## SERVICE INFORMATION NO. SI 42-082

GARMIN – Service Bulletin No. 0823  
ATA-Code: 34-00

**NO.: 0823**

**SUBJECT:** GDU 104X CRS/BARO Knob Interference

**Figure 1**

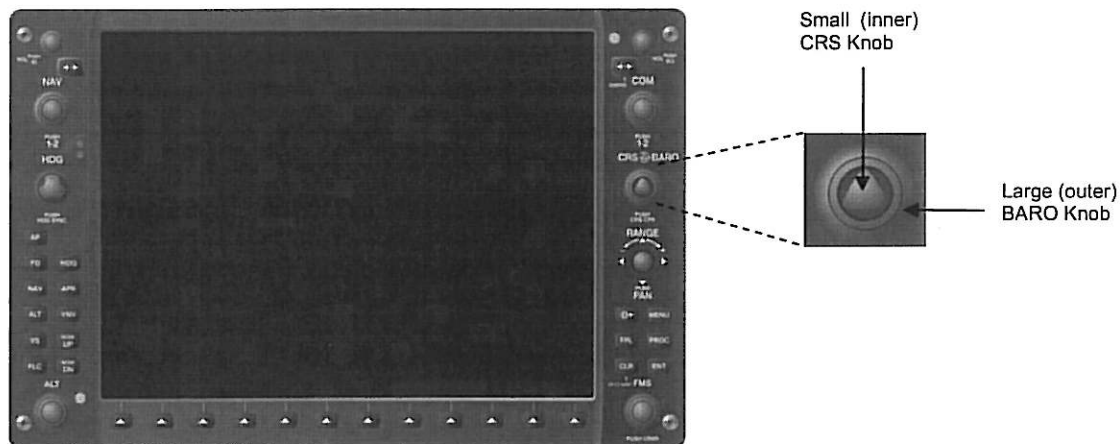
Garmin has identified an issue, whereby the large (outer) BARO knob and the small (inner) CRS knob may interfere with each other.

1. Apply power to the G1000/G900X/G950.
2. Press the CDI softkey on the Primary Flight Display(s) (PFD) to enter VOR mode on the HSI.
3. Rotate the large (outer) BARO knob (refer to Figure 1) a minimum of three complete revolutions in each direction while monitoring the Horizontal Situation Indicator/Digital Course Indicator (refer to Figure 2) on the PFD. If a change in the Horizontal Situation Indicator/Digital Course Indicator is produced while turning the BARO knob proceed to the Modification Instructions.

4. Rotate the small (inner) CRS knob (refer to Figure 1) a minimum of three complete revolutions in each direction while monitoring the Barometric Altimeter Setting (refer to Figure 2) on the PFD. If a change in the Barometric Altimeter Setting is produced while turning the CRS knob proceed to the Modification Instructions.
5. Repeat Steps 3 and 4 for each affected GDU.

1. Grasp the small (inner) CRS knob and firmly pull the knob off the shaft.
2. Discard knob.
3. Grasp the large (outer) BARO knob and firmly pull the knob off the shaft.
4. Discard knob.

5. Grasp the large (outer) BARO knob (insuring proper orientation) and place it over the shaft.
6. Align the flat side of the knob insert with the flat side of the shaft.
7. Press down firmly to ensure knob is completely seated, refer to Figure 3.
8. Grasp the small (inner) CRS knob (insuring proper orientation) and place it over the shaft.
9. Align the flat side of the knob insert with the flat side of the shaft.
10. Press down firmly to ensure knob is completely seated, refer to Figure 3.
11. Perform the CRS/BARO Knob Interference Test (contained in the TESTING PROCEDURE section) again to confirm there is no interference.
12. Accomplish aircraft logbook entry to return aircraft to service in compliance with this service bulletin.
